County of Loudoun  
Department of Planning  
MEMORANDUM

SUBJECT: SPEX 2006-0022 Western High School at Fields Farm 2<sup>nd</sup> referral

**COUNTY OF LOUDOUN**  
**DEPARTMENT OF BUILDING AND DEVELOPMENT**  
**ZONING ADMINISTRATION REFERRAL**

Figure 10.

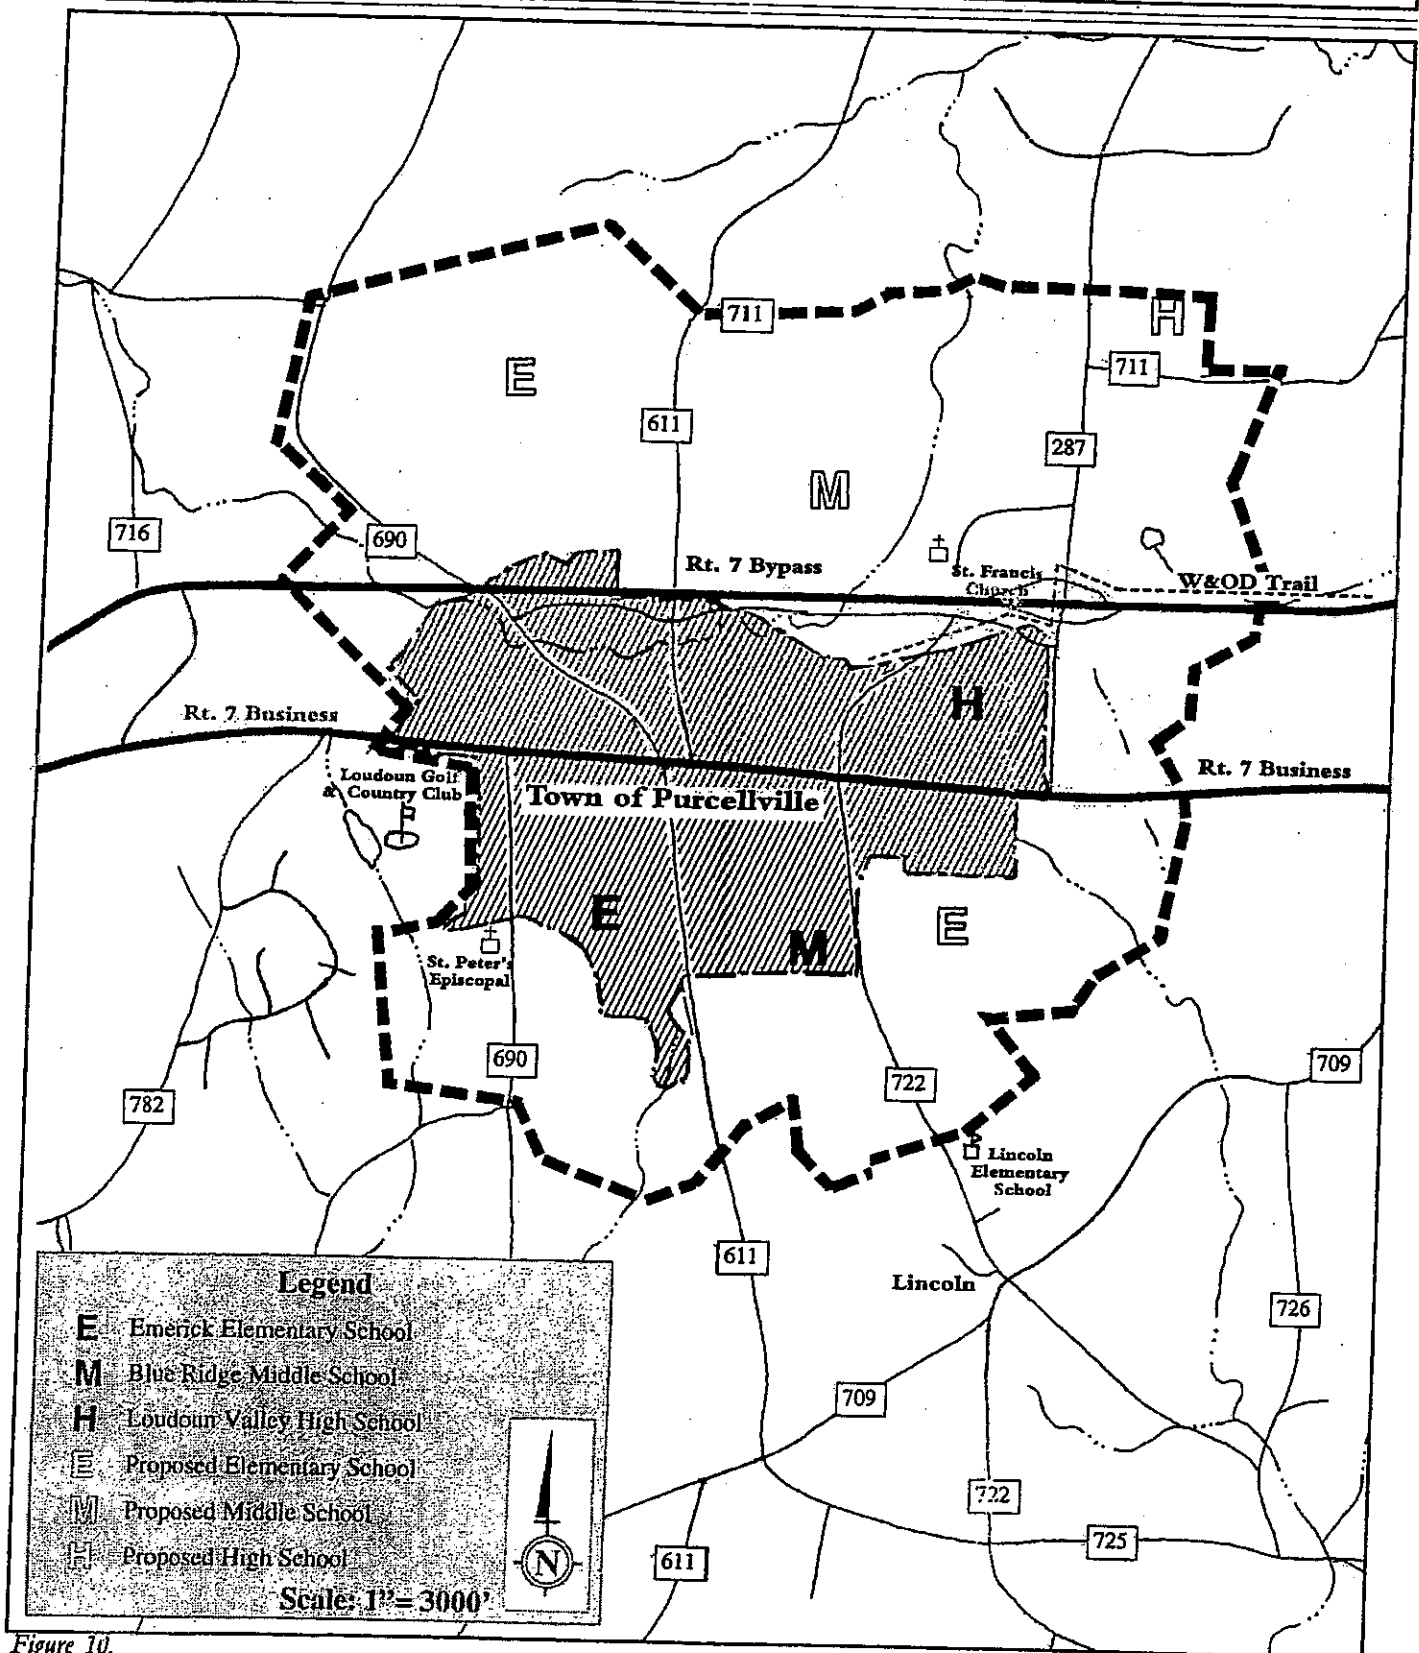
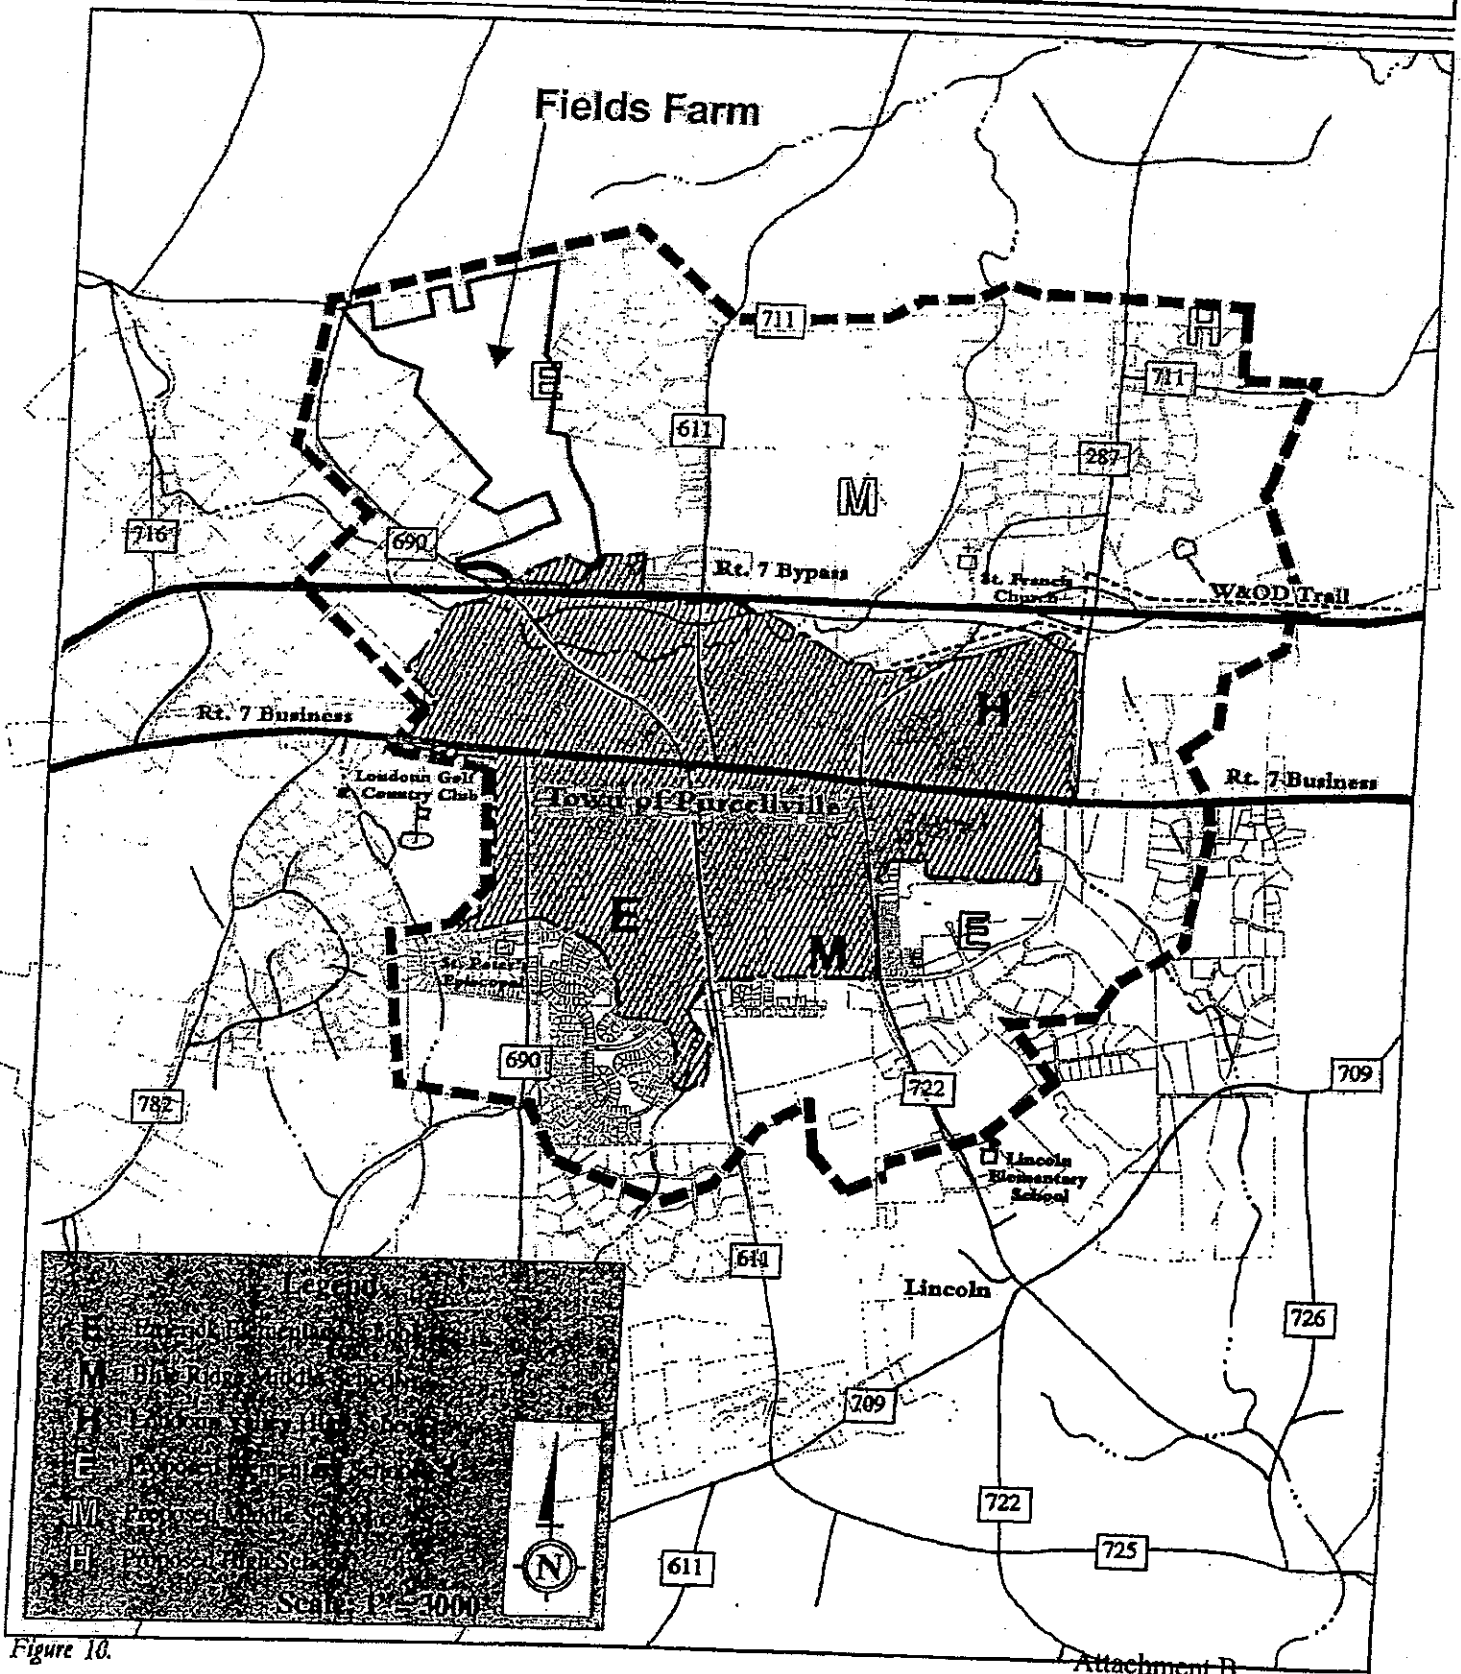
There are specific “preferred school sites” shown on Figure 10 for proposed elementary, middle and high schools (designated by an outline E, M and H, respectively). As noted above, the County Planning staff agrees that there was a “specific” high school site on Figure 10. The proposed Fields Farm high school site is on the northwestern edge of the PUGAMP area in a completely different quadrant than the Figure 10 designated high school site, which lies on the northeastern edge of the PUGAMP area east of Route 287. The entire width of the PUGAMP area on the north side of Route 7 is only 3 miles, and the Fields Farm property is located about two miles from the preferred high school site identified on Figure 10. This can hardly be considered the same “approximate location”. (See Attachment B).

The preferred high school site was not arbitrarily placed on Figure 10 when the plan was adopted in 1995. The high school site was located along the Rt. 287 corridor due to its convenient access to the grade-separated interchange with the Rt. 7 Bypass and its location within the largest land holding at the time within the PUGAMP area (the Wright Farm, which was under single ownership and included approximately 484 acres on both sides of Rt. 287). Since the School Board sometimes receives donated school sites as part of proffered rezonings, and Wright Farm is an area designated for possible higher residential zoning in PUGAMP, the high school site on Wright Farm could potentially have been donated through a rezoning application covering this site.

An elementary school is shown on Figure 10 approximately on Fields Farm. Thus, the Town did not object to the County’s location of Mountain View Elementary School on Fields Farm without a commission permit from either the Town or County Planning Commissions.

Although the referenced studies in paragraph #3 on page 58 have been completed since adoption of PUGAMP in 1995, the process of reevaluating these preferred school sites has never taken place. There are two ways that the proposed or preferred school sites shown on PUGAMP Figure 10 could be changed in accordance with the intent of PUGAMP policies regarding such a process, as stated on pages 48 and 58 cited above.

One way would be to amend the PUGAMP plan to change Figure 10 to show a high school on Fields Farm. This would require recommendations by both the County and Town Planning Commissions and approval by both the Town Council and the Board of Supervisors, in accordance with the Town/County Annexation Agreement, relevant State law and Town and County comprehensive plan amendment procedures.
